Resubmittal 3

Colby Rezoning and Subdivision
15635 Pecos Street

COLBY SUBDIVISION

A RESUBDIVISION OF LOT 8, BLOCK 1, NORTHWEST ESTATES

SHEET 1 OF 2

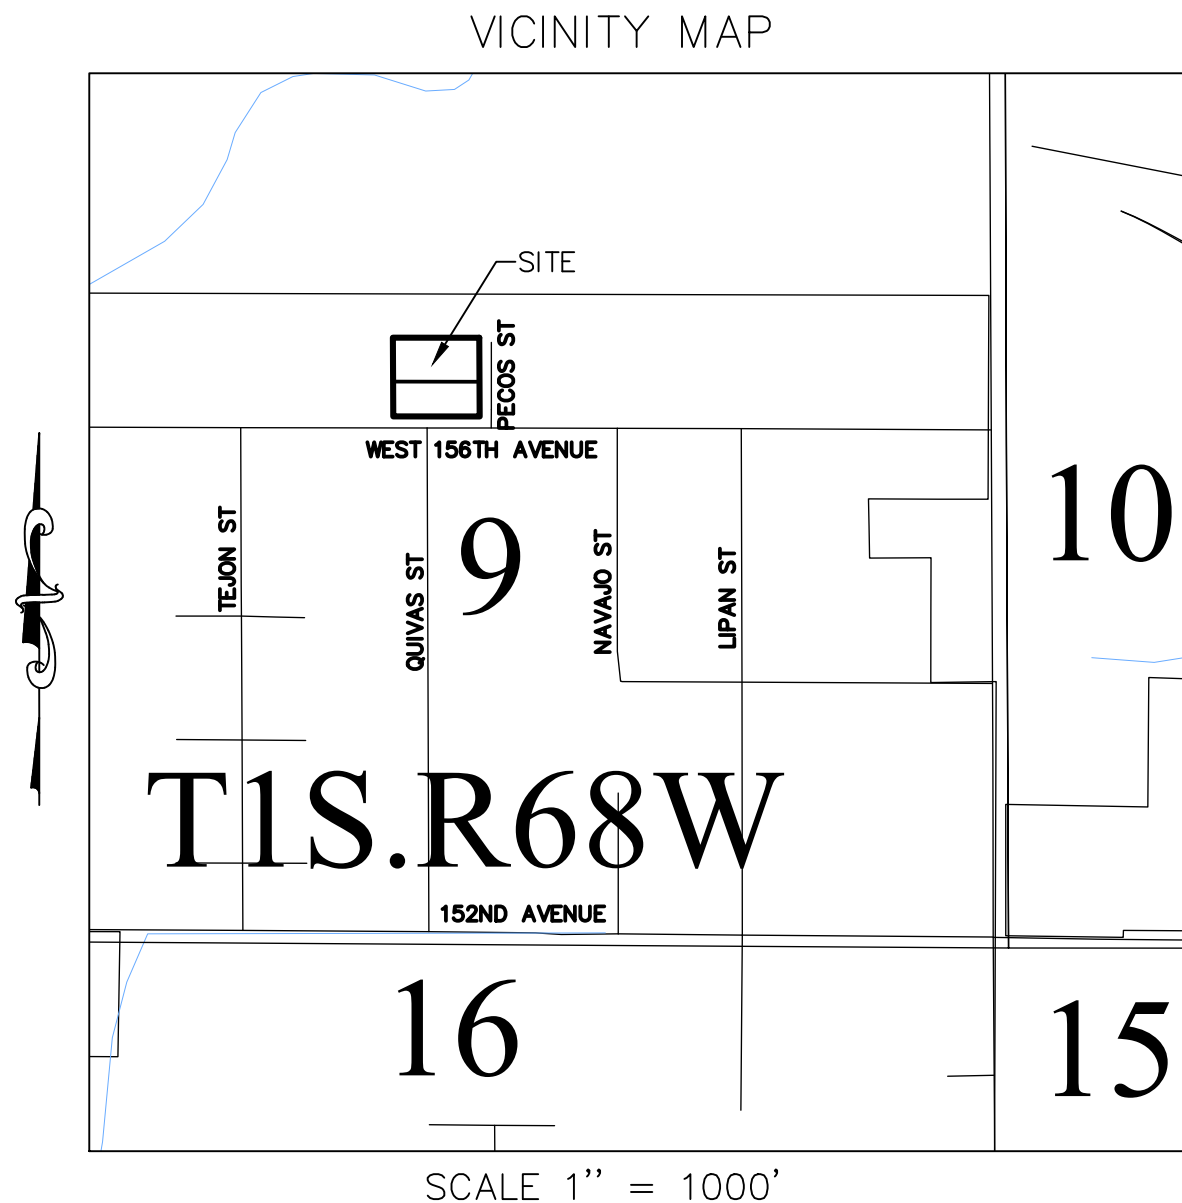
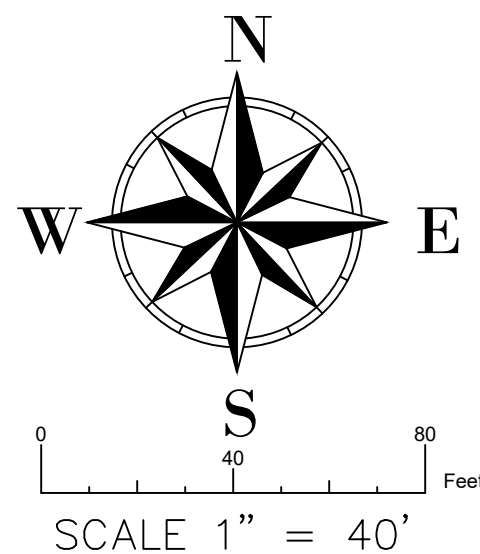
ROW1: Sheet 1

- Note 10 is duplicated with note 11. Once revised this will change numerical order for Note 15 and the statements on Sheet 2
- Access Provision: Access for lot 2 is restricted to Pecos St. No Access to West 156th Avenue will be allowed.

See updated plat.

SHEET 2 OF 2

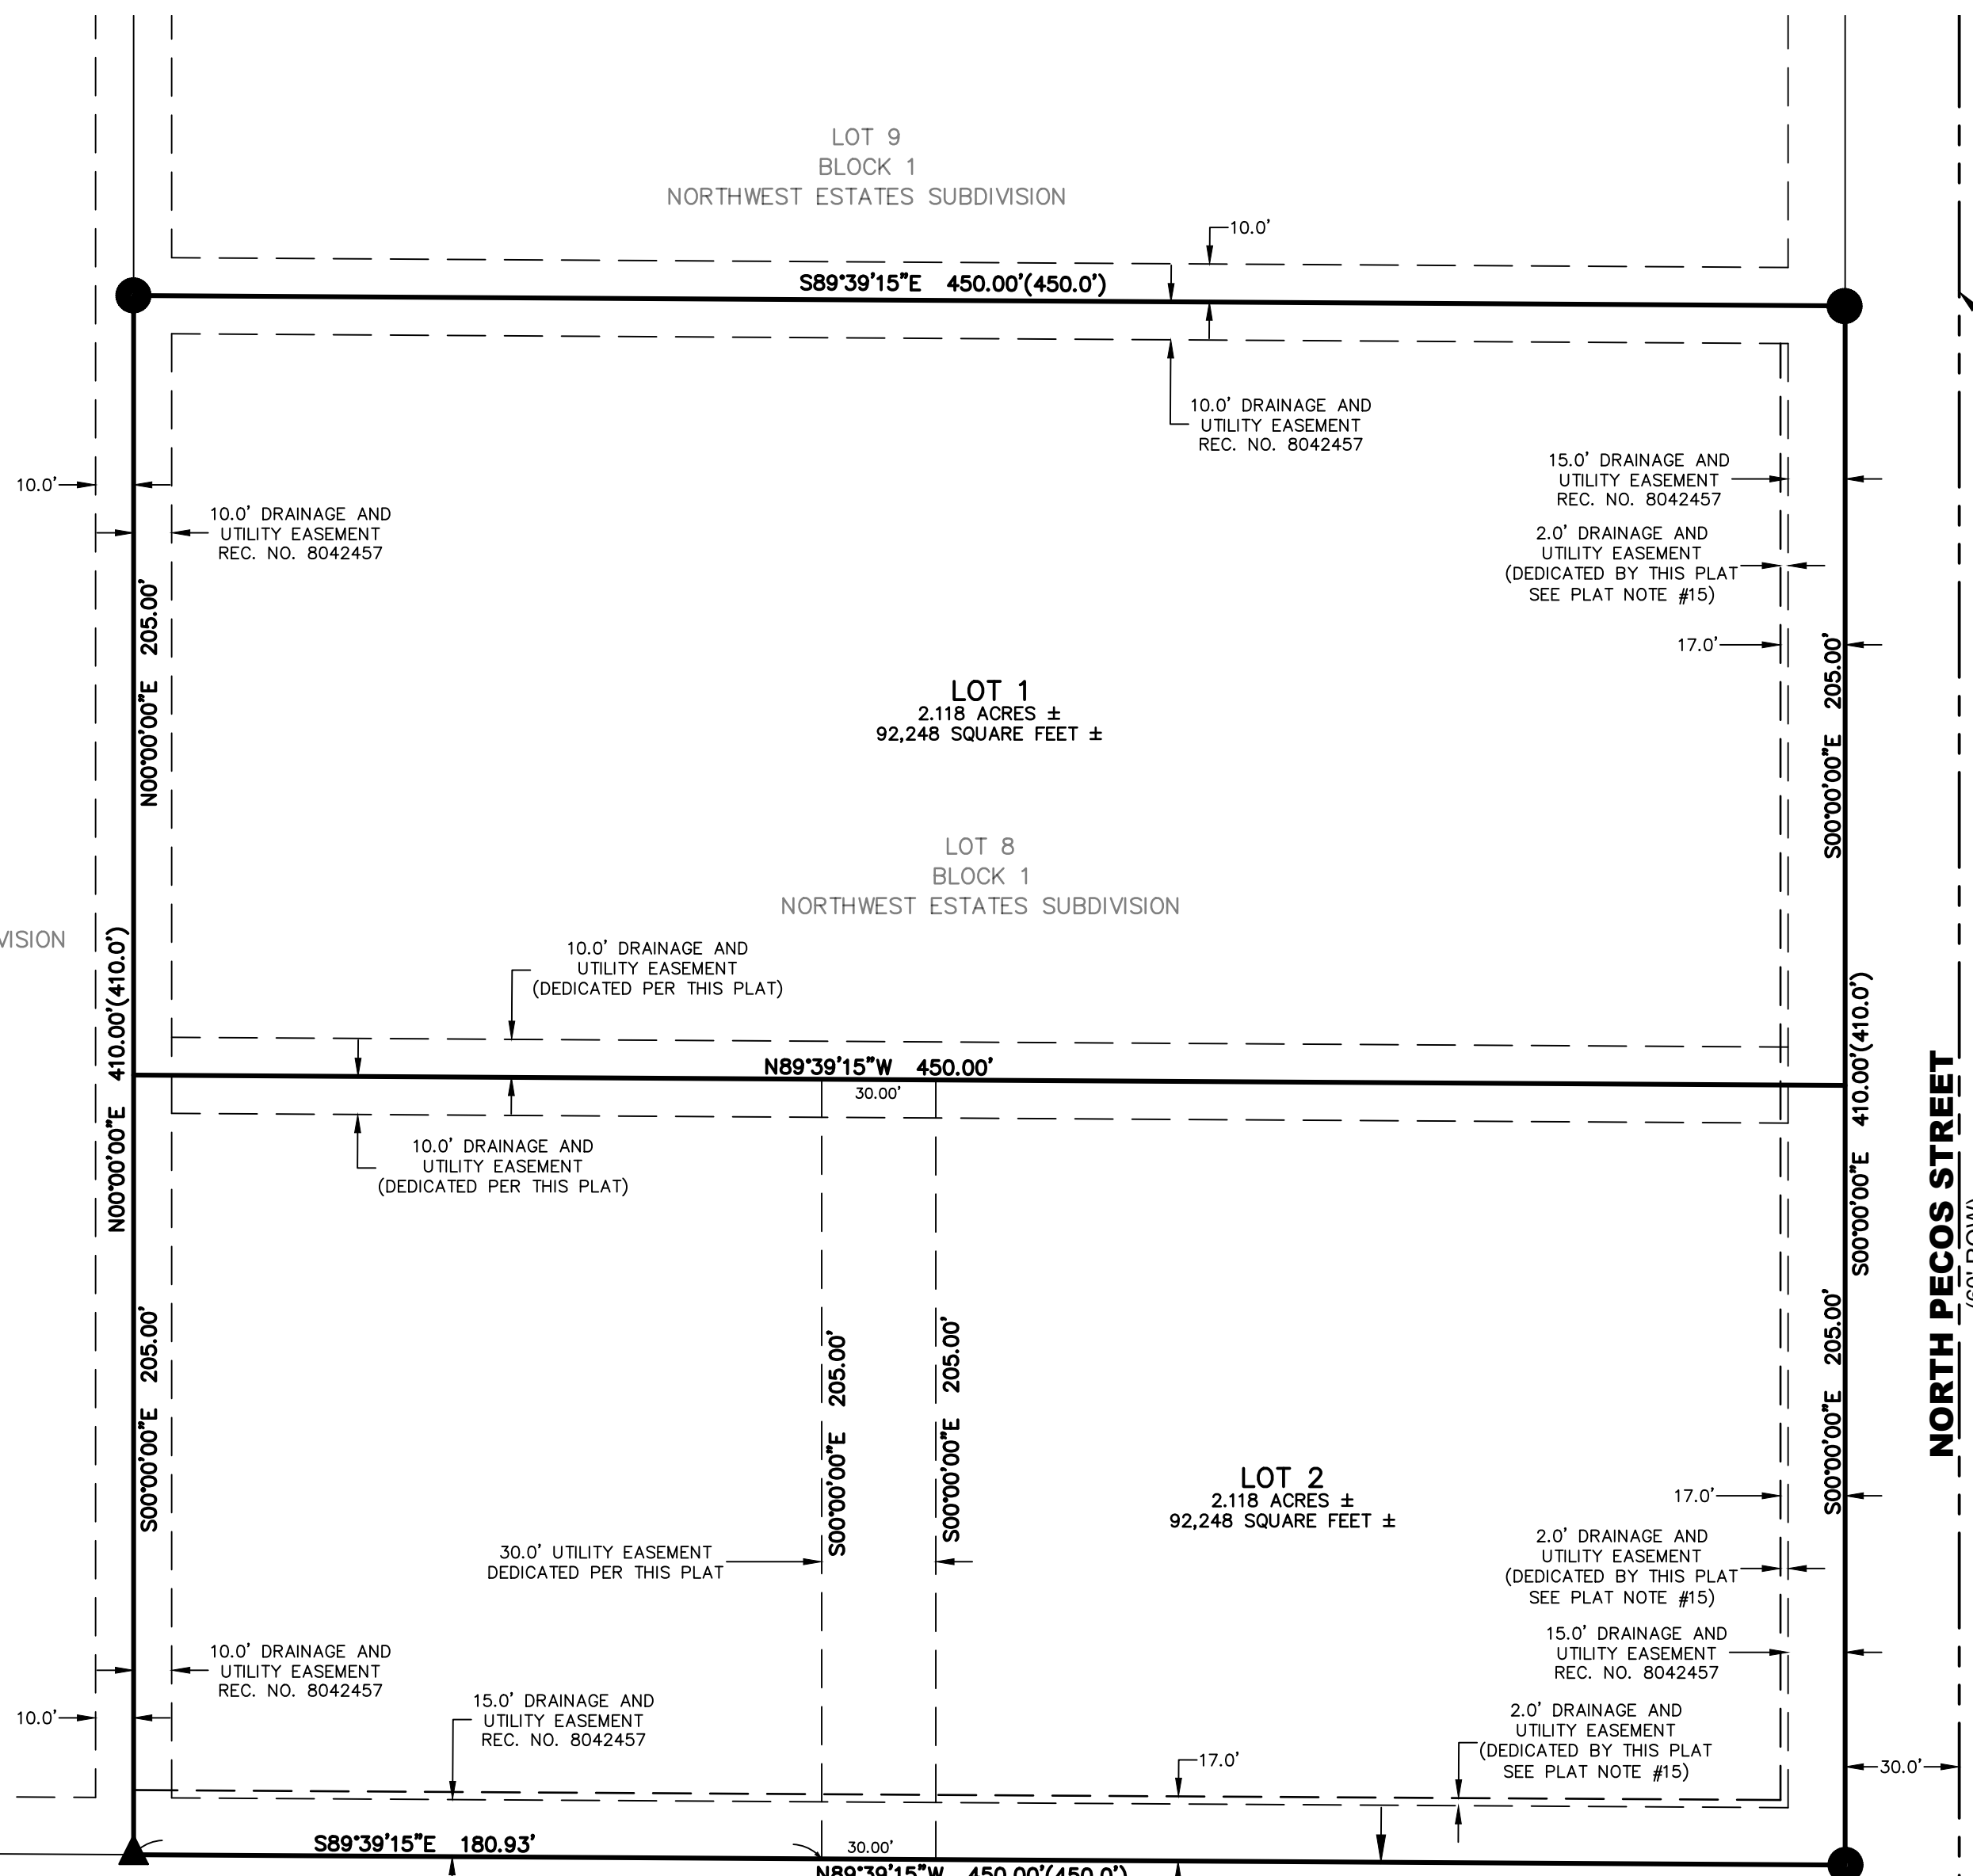
ROW2: Sheet 2

- Remove the superfluous information concerning the water line easement. It must be a UTILITY easement only. Otherwise the water district must be a signatory to the plat to accept this dedication. Also, do not believe a leach field can be crossed by this water line. Verify regulations. You can legally cross an easement located on individually owned property.

See updated plat. We do intend for the easement to be a utility easement only. We do not intend for any leach field to cross the water line.
